CUSTOMER NOTICE OF PRODUCT/PROCESS CHANGE

Customer Name:	All Customers
CTS Part Number:	220AMA04R, 220AMB04R, 220AMC04R, 220AMA10R 220AMB10R, 220AMC10R, 220AMA16R, 220AMB16R 220AMC16R, 220ADA04, 220ADB04, 220ADC04, 220ADA10, 220ADB10, 220ADC10, 220ADA16, 220ADB16, 220ADC16

Description of Change: New design of housing and terminal change with new shape, print on the surface and increase of thickness

Table 1- Old Product Structure

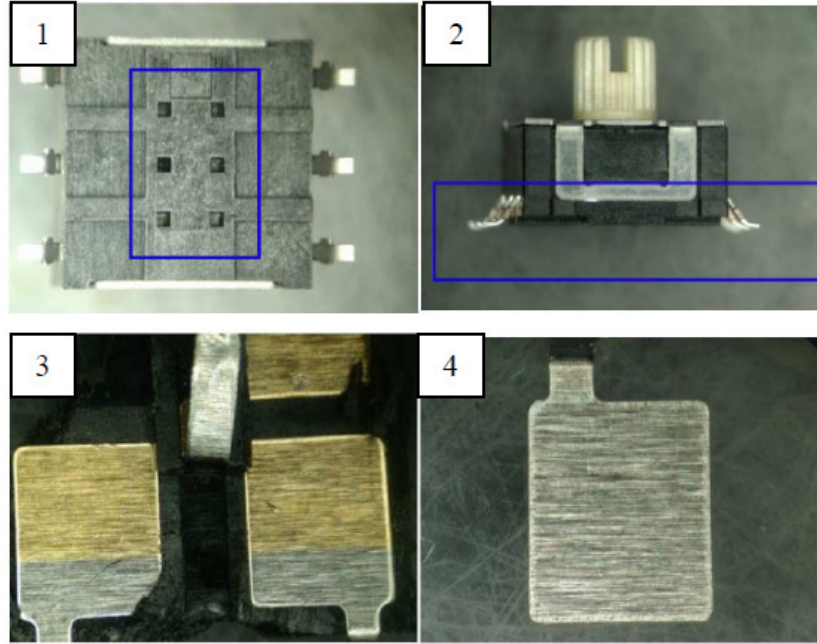
(1) 6 holes at the bottom for plastic injection purpose.

(2) Terminal thickness was 0.15mm.

(3) No V shape notch on the terminal.

(4) No print of mark on the back of terminals.

(1) Block the holes on the bottom of housing and add the No. of output, which will prevent the flux to intruding..

(2) Increase the terminal thickness from 0.15 to 0.25mm, which will avoid terminal deformation in the application.

(3) Add the V shaped notch at the start of terminal. The V shaped will obstruct the flux to move to contact area.

(4) Add the print of mark on the back of terminals. The print of mark will obstruct the flux to move to contact area.
